HARRIS BRANCH COMMERCE PARK
PROPOSED WETLANDS & SETBACKS

CITY OF AUSTIN –DEVELOPMENT SERVICES DEPARTMENT SUBDIVISION APPLICATION – MASTER COMMENT REPORT

CASE NUMBER: C8-2022-0330
UPDATE: U1
CASE MANAGER: Juan Enriquez, Senior Planner juan.enriquez@austintexas.gov

PROJECT NAME: Harris Branch Commerce Park(W/R C8-2020-0186)
LOCATION: 6400 E PARMER LN

HARRIS BRANCH COMMERCE PARK
EXISTING WETLANDS & SETBACKS

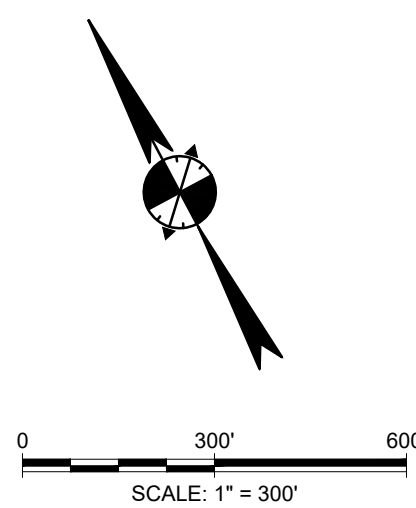
UPDATE 1. All wetland CEFs are still only visible on sheets G and H. Add and label wetland CEFs on all plan sheets where they exist. Comment pending.

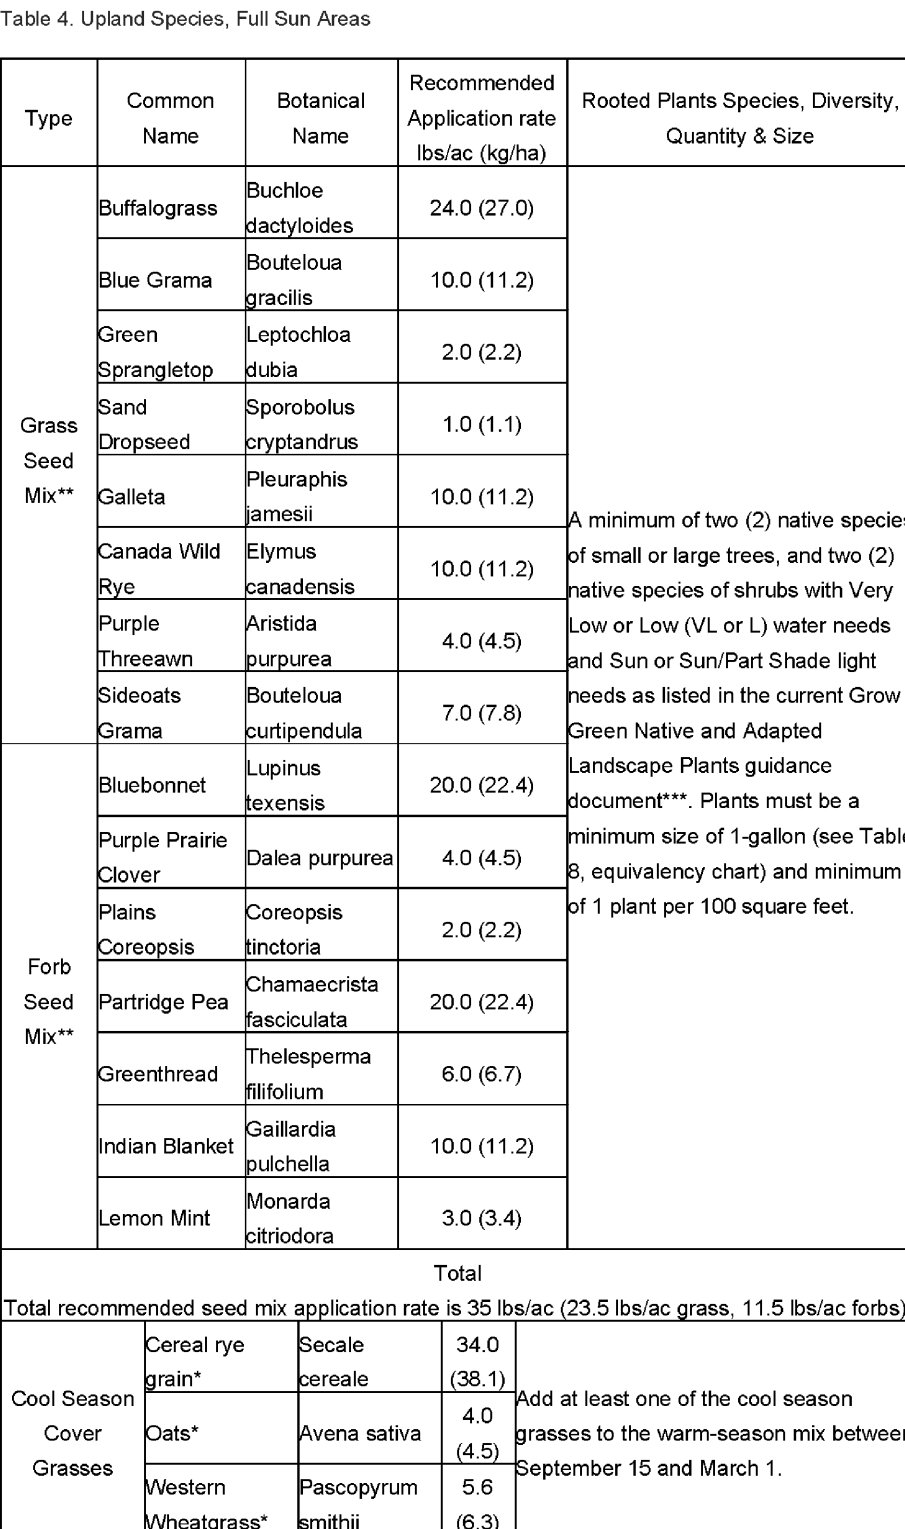
Additional information: *{This comment can be addressed by clearly showing and labeling "WETLAND CEF SETBACK" on all plan sheets where the CEFs and CEF setback are contained within the area shown. Use the CEF setbacks as they are proposed and shown on exhibit H.}*
UPDATE 1. All wetland CEF setbacks are still only visible on sheets G and H. Add and label proposed wetland CEF setbacks on all plan sheets where they exist. Comment pending.

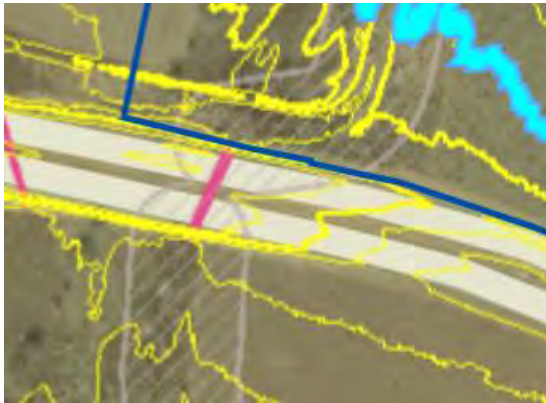
- FP1: The modeling provided does not meet requirements set in the Drainage Criteria Manual Section 2 "Determination of Storm Run Off." Modeling must be in compliance with criteria prior to approval. HMS output values do not match flows in RAS. Provide an HMS/RAS correlation table for both tributaries in the engineering report. **U0: Comment cleared.**
- FP2: The modeling provided does not meet requirements set in the Drainage Criteria Manual Section 6 "Open Channels." Modeling must be in compliance with criteria prior to approval. HMS output values do not match flows in RAS. Provide an HMS/RAS correlation table for both tributaries in the engineering report. **U0: Comment cleared.**

- FP3: Confirm that no modifications are proposed at subdivision construction phase for either tributary on the lot. U0: No modifications are proposed at construction stage, the engineer states that channel widening is proposed with a later site development permit. It is unclear if the modeling is showing existing or proposed geometry conditions. Engineer will be required to show existing conditions floodplain and contain the existing 100-year floodplain to a drainage easement. Based on the comment responses and how the plans are shown, it appears that proposed conditions are being modeled and delineated. If channel modifications are changed to be completed during the subdivision construction plans, show both the existing and proposed RAS models with their respective existing and proposed geometries. The same flow files should be used. Once the proposed floodplain is reviewed and approved to ensure no adverse impact, the proposed drainage easement may contain the proposed floodplain. At construction plan formal review, the floodplain reviewer will ensure that the channel modifications are proposed and are shown as the same as what was submitted for the preliminary plan. **U1: There is an adverse impact shown at XS 1072.66 in the proposed conditions which shows an increase of .36 feet, and the floodplain leads offsite before the rise is at or below existing conditions. Rises in WSEL offsite are prohibited. See FYI comments at the bottom of the document for more information.**

- FP4: Provide explanation for manning's n value of .04 for the entire channel within the floodplain report. This value is lower than typical channels for overbanks. **U0: Floodplain is mostly grassland. Comment cleared.**

- FP5: Provide explanation for ineffective flow for all cross sections within RAS in the report. **U0: ineffective flow areas are gone from the model; the engineer states that they have been addressed by expanding the channel cross section where appropriate. Comment cleared.**

- FP6: Provide a more concise hydraulic workmap for both tributaries. The workmap should include the 100-year ATLAS 14 floodplain, contours, contour values, drainage/proposed drainage easements, Cross sections, and WSEL's at each cross section within the floodplain report. **U0: Comment cleared.**

- FP7: Include a cross section just upstream of the culvert on the lot for the southern tributary with a contraction/expansion coefficient of .3/.5 respectively. Include the culvert in the RAS modeling as well. U0: Culvert added at silicon drive, however there has been no culvert added at the downstream end of the site under Parmer Lane. The existing culvert under Parmer Lane for this tributary needs to be modeled, and a cross section just upstream and downstream of the culvert should be added as well with a contraction/expansion coefficient of .3/.5 respectively. See screenshot below of culverts that should be added. The private culverts can be seen in pink. **U1: Comment cleared. Culvert is shown.**

- FP8: Bank stations should be at around the 2-year WSEL, or where the main channel changes to the overbanks. Update your bank stations in RAS. **U0: Bank stations not adjusted; however it does not appear the manning's n value with vary much in this area. Comment cleared.**

(Proposed)^

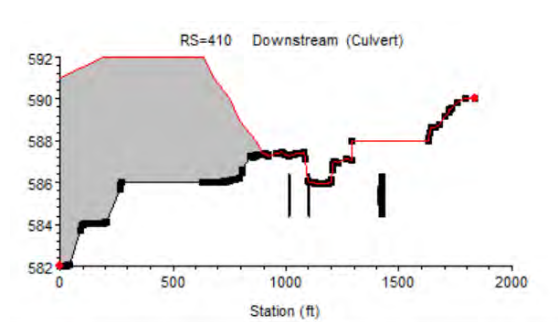
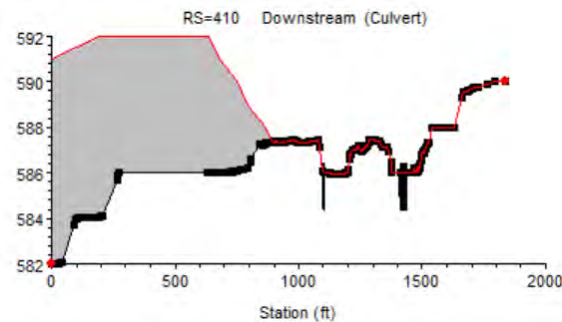
FYI: The downstream culvert geometry at RS 410 in proposed conditions looks different than existing conditions. Unless there are modifications of the culvert the culverts should have the same geometry in existing and proposed conditions. See the screenshots below for reference.
